Product Change Notice (PCN)

PCN Number: PCN-0450063R-01

Product(s) Affected: MD-30SP, MD-40SP, MD-50SP, MD-60SP, MD-70SP, MD-80SP

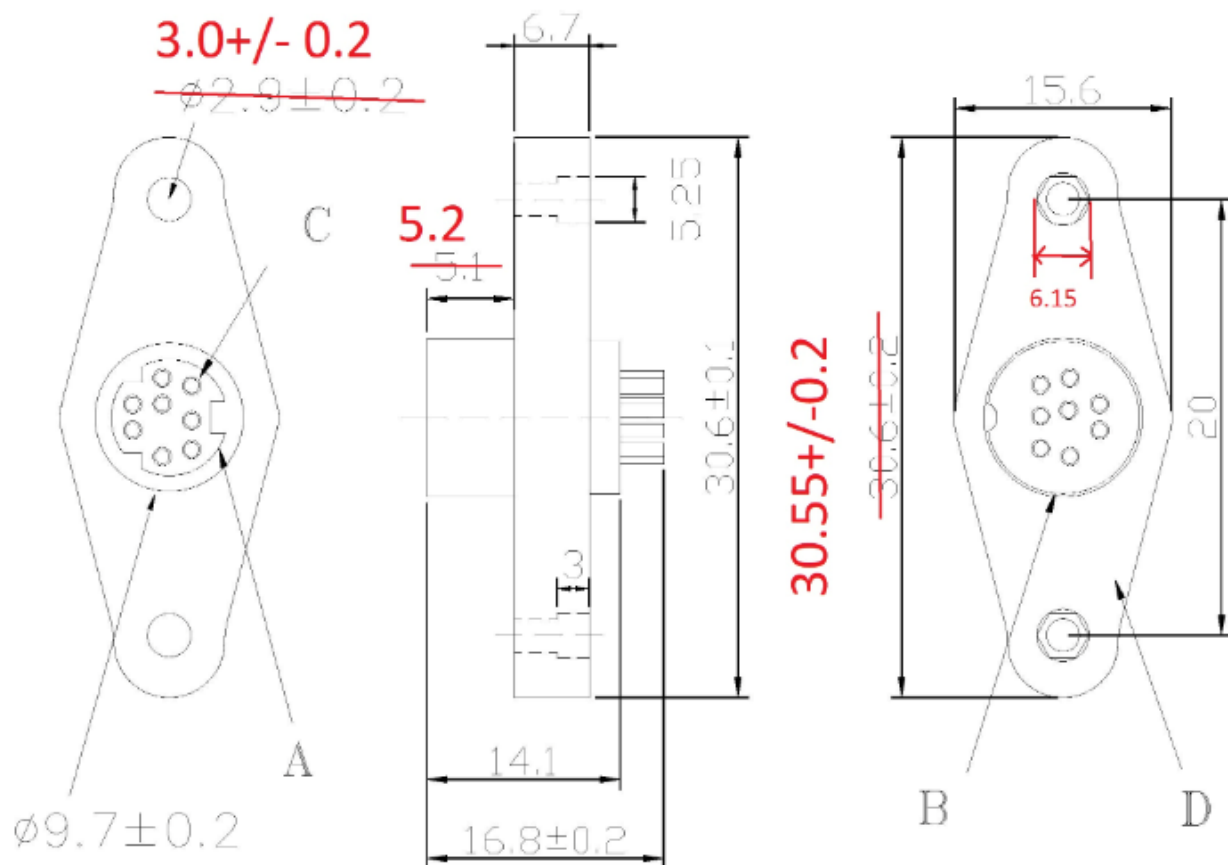
Description of Change: Slight mechanical differences as noted below, all of which are within tolerance of original design.
